July 15, 2013
NRC-13-0035

Subject: Response to Request for Additional Information for Measurement Uncertainty Recapture Power Uprate License Amendment Request

Fermi 2 NRC Docket No. 50-341
Operating License No. NPF-43

Response to EMCB and EEEB RAIs

Generator Capability Diagram

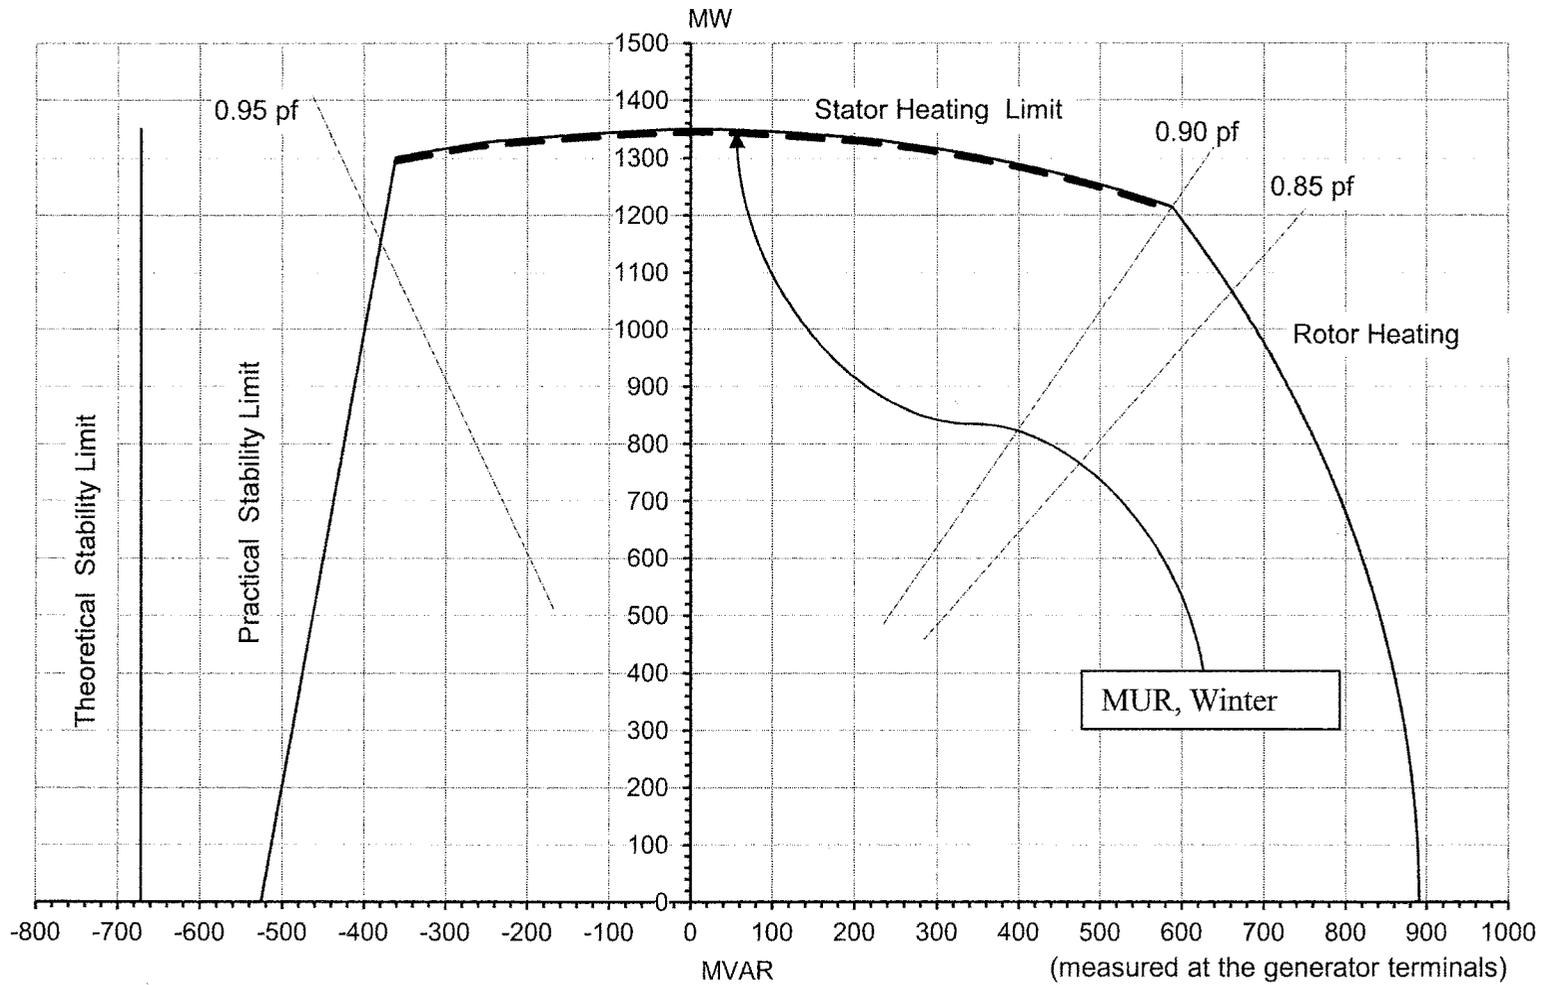
On page 6-1 of Enclosure 7 of the LAR, the licensee stated that the main generator will be operating within the existing generating capability curve for TPO uprate, and, for the summer and winter operations, the gross generator Megawatts electric (MWe) output is on the existing generator capability curve at a rated power factor of 0.90. Provide the gross generator MWe output for summer and winter operations at CLTP and TPO uprate conditions. Also, provide a copy of the main generator capability curve, to show that the generator will continue to operate within the limits of its capability curve.

The main generator capability curve is provided below.

Customer : Detroit Edison **Station :** Enrico Fermi Unit 2 **Serial Number :** DAX3231/0005 **Figure no. :** CD 16716 (modified)
Frame size : TG65-327-116 **Rating :** 1215 MW, 0.9pf, 22 kV, 60 Hz, 75 psig hydrogen pressure
